UNITED STATES  
NUCLEAR REGULATORY COMMISSION  
ADVISORY COMMITTEE ON REACTOR SAFEGUARDS  
WASHINGTON, D.C. 20555-0001

**SUBJECT: SUMMARY REPORT - 516<sup>th</sup> MEETING OF THE ADVISORY COMMITTEE ON REACTOR SAFEGUARDS, OCTOBER 7-9, 2004, AND OTHER RELATED ACTIVITIES OF THE COMMITTEE**

1. Safety Evaluation of the Industry Guidelines Related to Pressurized Water Reactor (PWR) Sump Performance

Figure 1. Comparison of NUREG/CR-6224 correlation with Test 6G head-loss data.

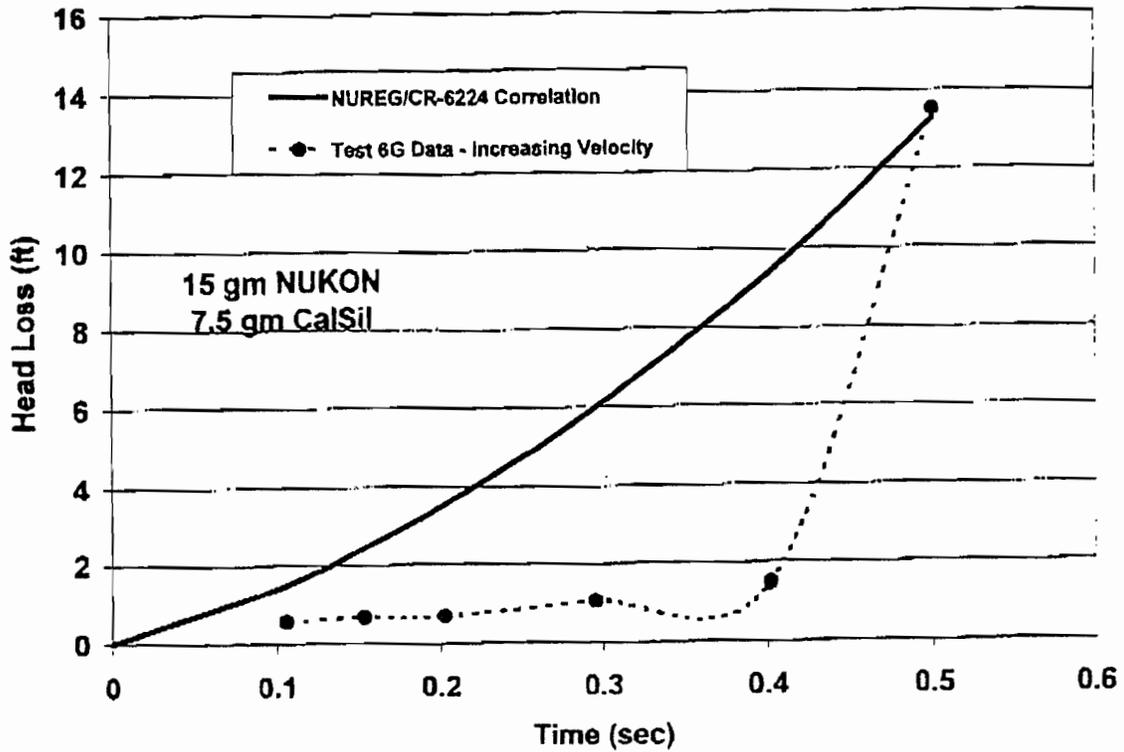
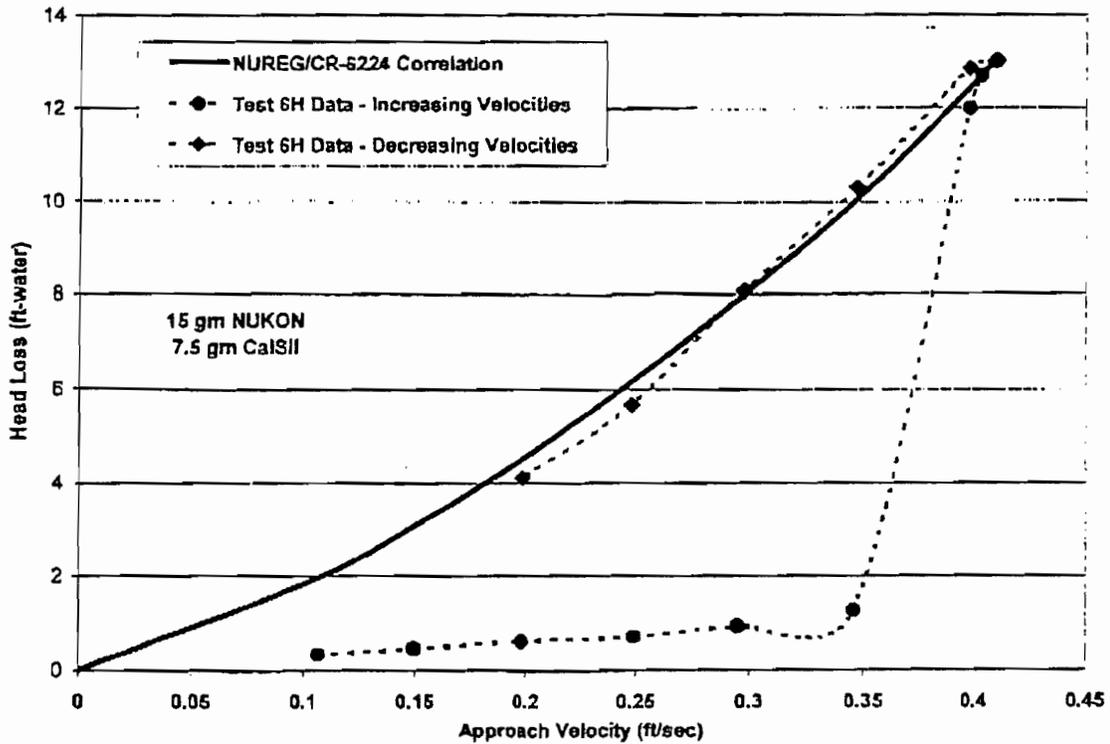
Be that as it may, the recommended values come from these tunable parameters being adjusted to fit Tests 6G and 6H. These are taken from the LANL report and are shown in Figures 1 and 2 here. Note that the highest point in Test 6G to which the fit was made may or may not be the highest pressure loss. (The x-axis in Figure 1 appears to be mislabeled and should probably be approach velocity). The trend of the increasing velocity lines can be continued to indicate that the pressure loss could perhaps have been higher (double or more). If the velocity had then been decreased, perhaps it would have followed a line from the "NUREG correlation" that was higher—and was based on a higher specific surface area.

Figure 3. Comparison of NUREG/CR-6224 correlation with Test 6C head-loss data.

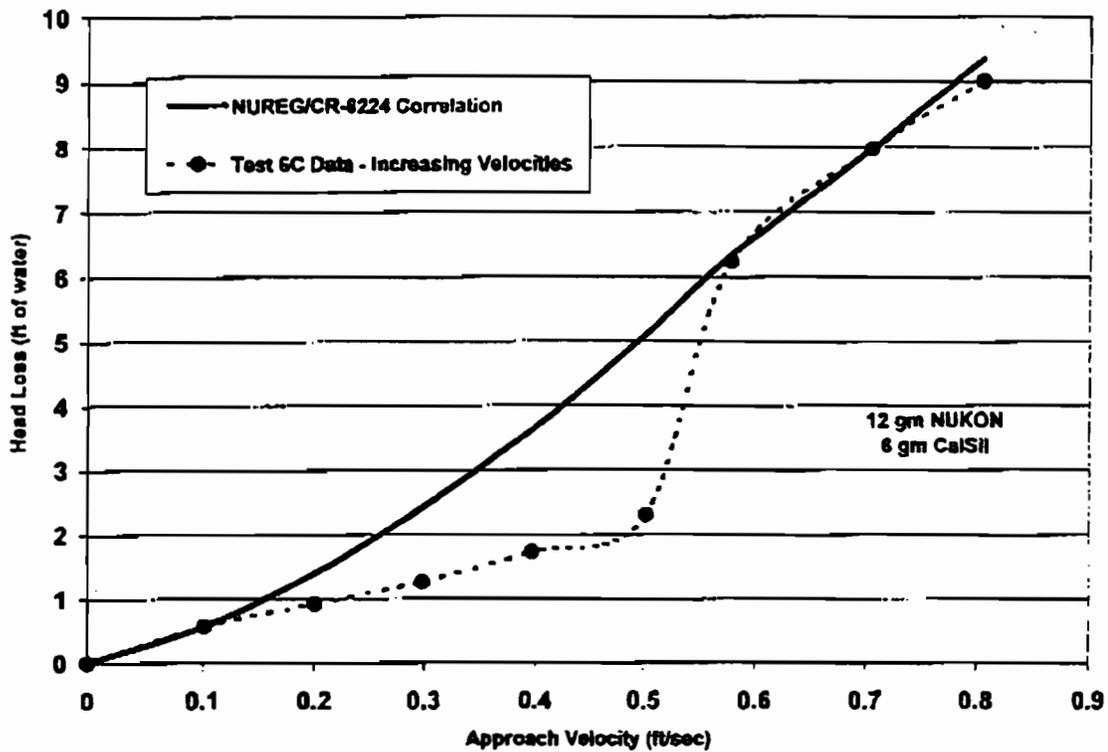
To be conclusive, 6G and 6H would have had to be done like Test 6C shown in Figure 3. Here the approach velocity was increased until several points with increasing velocity could be fitted to the "NUREG correlation". Until such a procedure is followed for conditions corresponding to 6G and 6H, the experimental data should not be used to recommend values for the specific surface area and the sludge density even for the questionable NUREG correlation.

Figure I-1, ANSI Jet-Model Stagnation Pressures for PWR Cold-Leg Break Conditions (530°F, 2250 psia)

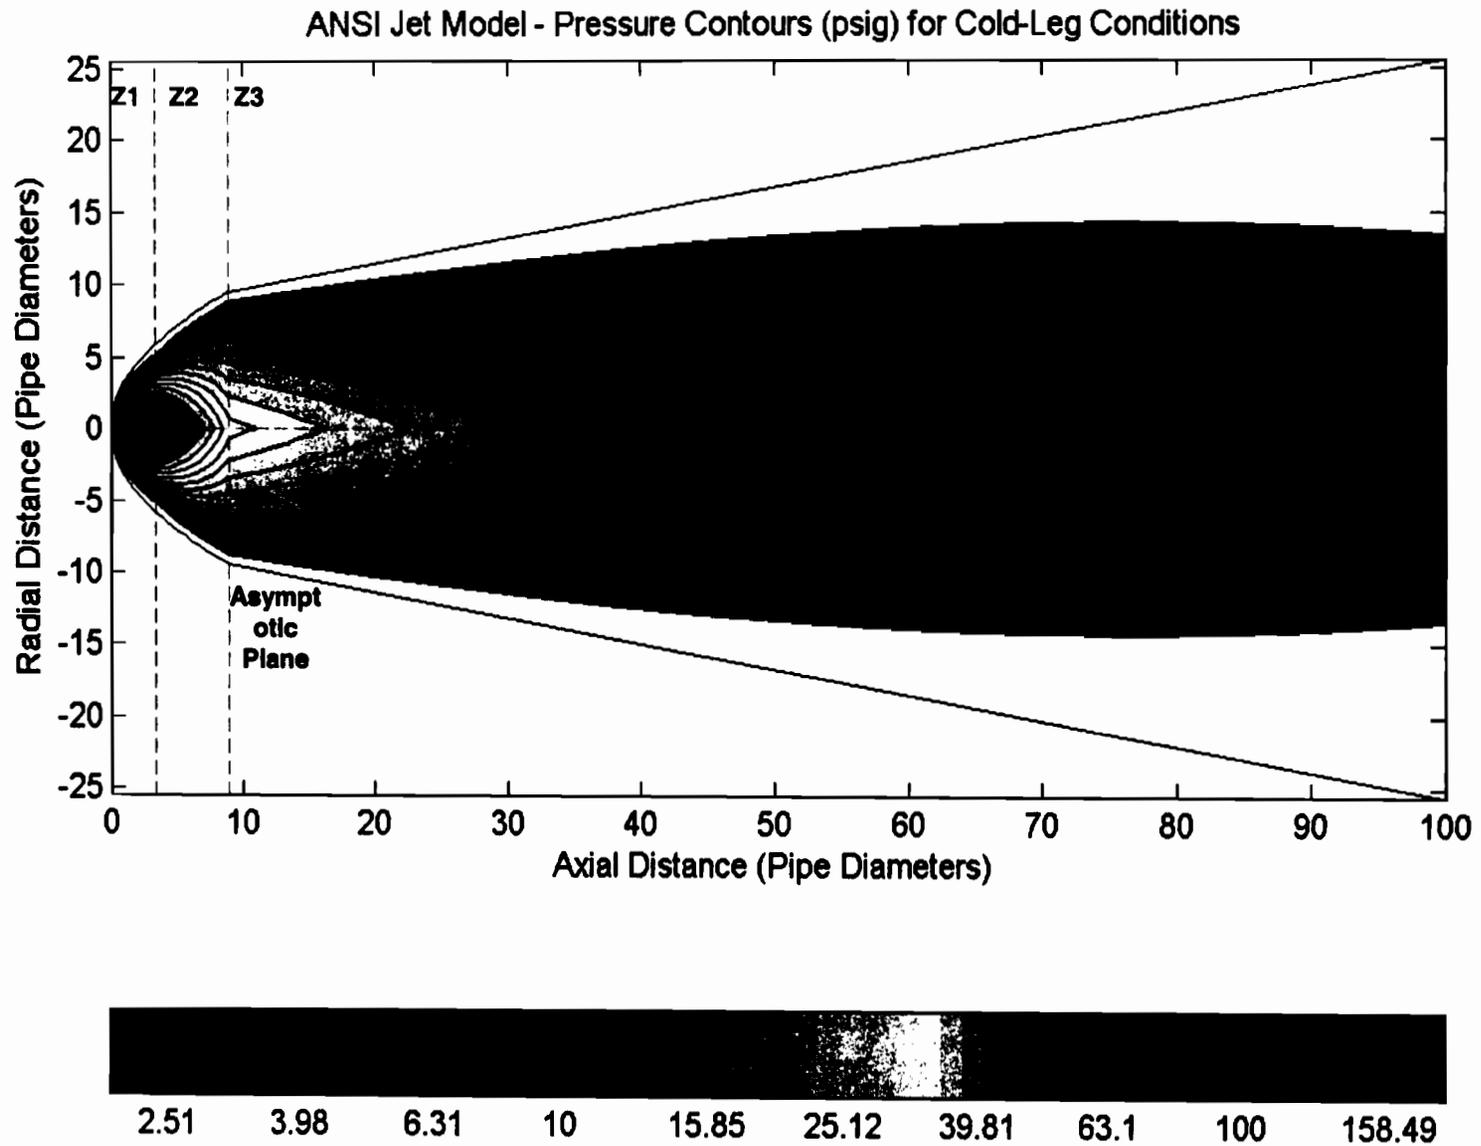
boundary of the core. There is no similar constraint provided in Equation (I-20), so there will be a sharp discontinuity in pressure at the boundary of the jet core when this condition is invoked, as shown in Figure I-1. Equations (I-19) and (I-20) were not intended to be evaluated inside of the core region. Within the core, the system stagnation conditions are presumed to hold.

The sharp tip of each contour shown in Figure I-1 is another nonphysical feature of the ANSI model that arises from lack of attention to matching spatial first derivatives. It

- A discontinuity in the slope of the isobars exists between Zones 2 and 3. This discontinuity is clearly evident in Figure I-1. The sharp terminal points of pressure isobars at the axial centerline also suggest that more attention could be given to the behavior of first spatial derivatives.
